Bigos Kelley Park Phase III - Lot 9 & 10

Regarding: Public Hearing Comments

FRESCO TERRACE

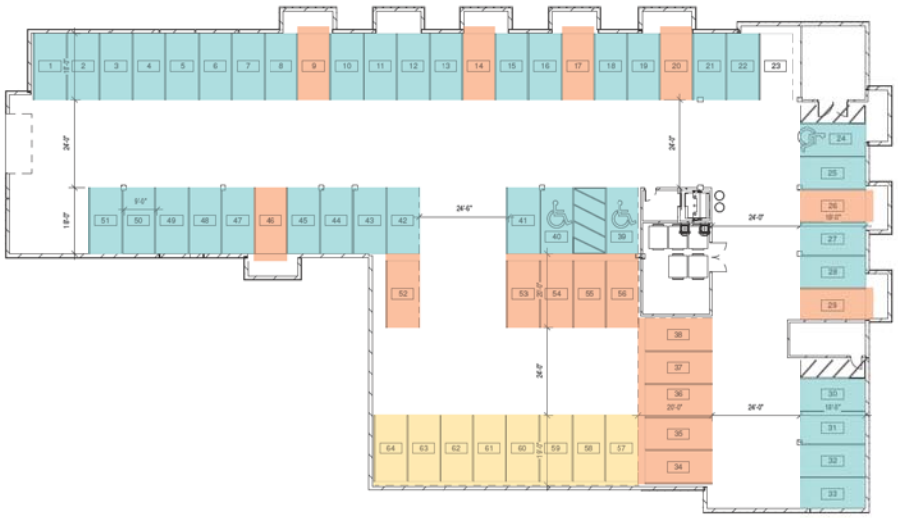
Provide renderings that show how the buildings will relate to Fresco Terrace.
A rendering showing both Lot 9 and 10 in relation to Fresco Terrace was submitted to the city on October 25, 2017.

ROOFTOP DECKS

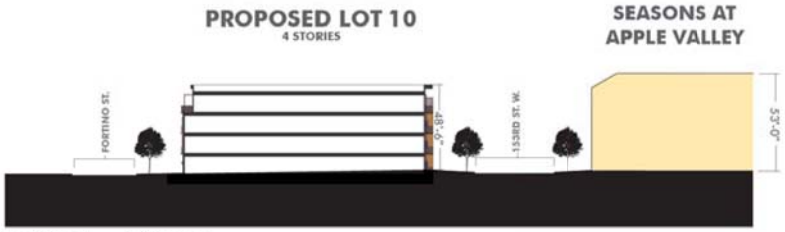
Block 9 has no pool or outdoor patio area. How will that be addressed?

Schematic plans for the rooftop decks have been submitted to the city on October 25, 2017. They both have been designed to overlook Kelley Park. The amenities on each includes grilling stations, firepit or outdoor fireplace, lounge furniture, dining tables, outdoor televisions, planters and shade structures. These spaces will have access control so that management can control the hours of use.

SITE SECTIONS

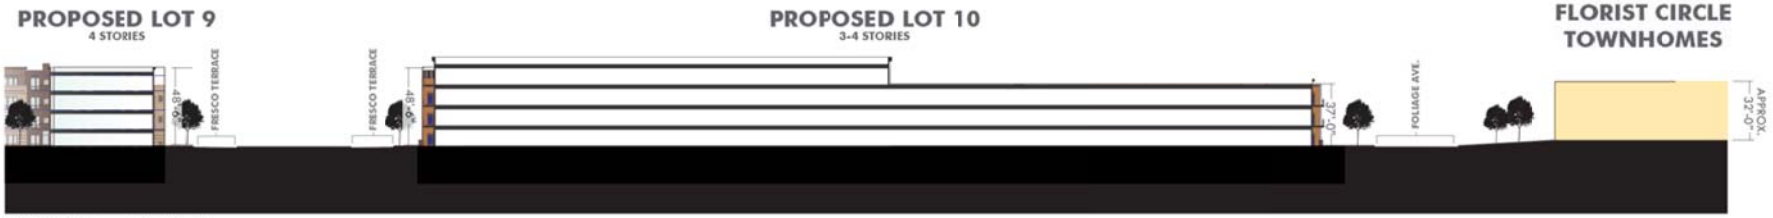
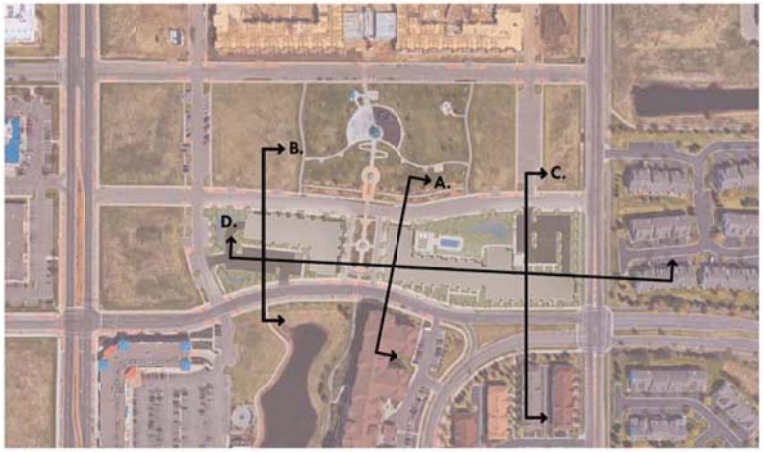
Buildings are being constructed 10' away from sidewalks. Are these livable units? What about pollution and noise? Thinks larger setbacks are needed.
As with Galante, windows with high STC (Sound Transmission Class) ratings will be specified to add increased acoustical isolation. Additionally, most streets surrounding this site are low-speed, and low traffic – i.e. Fortino Street, Galante Lane, and Fresco Terrace. In those instances, it is desirable for units to have a connection with the street to promote a sense of community and activate the streetscape. Residents with pets typically prefer these units to have direct access to the outdoors, or those who desire an urban feel. Along 153rd and Foliage, where there is increased traffic, there are limited portions of the building adjacent to the street. On Lot 9, the majority of the building adjacent to 153rd is the Live-Work space, in which high visibility from the street is desirable. On Lot 10 there are residential units adjacent to 153rd and Foliage, and while the building is setback 10', there is an additional sidewalk and median, so the actual distance to the

street is between 25'-30'. Bigos Management has no concern that these are rentable units. In fact, the price and demand for the street level units at Gabella are higher than floors 2-4.
